Staff Report & Recommendation

Design Review Board

SUBJECT: DRB18-0309
5860 North Bay Road

An application has been filed requesting Design Review Approval for the construction of a new two-story residence on a vacant site, including one or more waivers and a variance to exceed the maximum height for a one-story accessory structure in the rear yard.

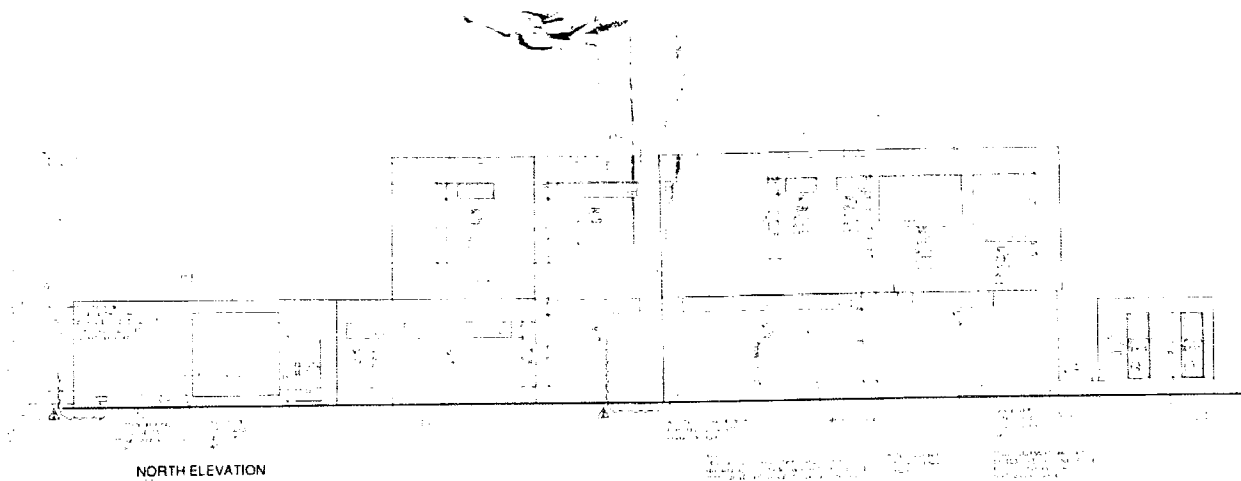
The applicant is proposing to construct a new two-story residence on a vacant waterfront parcel. The proposed design seeks two variances and three design waivers as part of this application. The first floor elevation of the new residence is proposed at base flood elevation (8' NGVD) plus a minimum free board of one foot (+9' NGVD).

The first design waiver pertains to the second floor to first floor ratio. Per the City's Code, when the lot coverage exceeds 25%, the second floor is restricted in massing to 70% of the first floor, unless a waiver is granted by the Design Review Board. As proposed, the home has a second floor to first floor ratio of 105%. In reviewing such waiver requests, staff considers several factors that include design, lot coverage and overall building massing. The home's proposed lot coverage relies on a large central entrance courtyard towards the overall number, which leads to massing being shifted towards both side portions of the residence. Staff is supportive of the additional design waivers for both side open space requirements and increase height for RS-3 zoned properties (see forthcoming analysis), this coupled with a larger than allowed second floor massing, staff finds that the design will impact neighboring properties. As such, staff does not support the requested waiver.

The applicant is also requesting two waivers of the open space requirement for two-story elevations that exceed 60'-0" in length without incorporating additional open space, for both side (north and south) elevations. The solid continuous portion of the north elevation spans 113'-6" in length and is broken up with an approximately 25'-4" wide and 9'-0" deep recess. The recess has been designed flush with the elevation of the first finished floor of the residence, or at 9' NGVD, and is configured with a passive water reflecting feature. As

designed, the proposed open space does not meet the open space requirements as it is not “100% open to the sky” from the ground up, yet is surrounded on three sides. While the resulting open space is higher than adjusted grade and is not landscaped, it does satisfy most of the regulation’s criteria and is consistent with the intent of the ordinance since the designated open space successfully breaks up the massing of the two-story elevation, and does not count towards the lot coverage of the site. Staff is supportive of the design waiver along the north side elevation and maintains the approval will not have an adverse impact on any abutting property since it directly abuts a 25’-0” unimproved right-of-way.

The solid continuous portion of the south elevation spans 74’-6” uninterrupted in length. The rectilinear massing of the house complies with the minimum 12’-10” side setback at the easternmost portion and expands westward as the diagonal south property line extends the proposed setback amount to above 20’-0”. The abutting property to the south contains a new two-story residence built in 2015. City records (building permit No. B1504644) indicate that the residence was designed with a 9’-7” setback along the north side that expands to 11’-3” with a side open space recess that complies with all of the regulations. The elevation features predominantly ribbon windows along this elevation (see below):
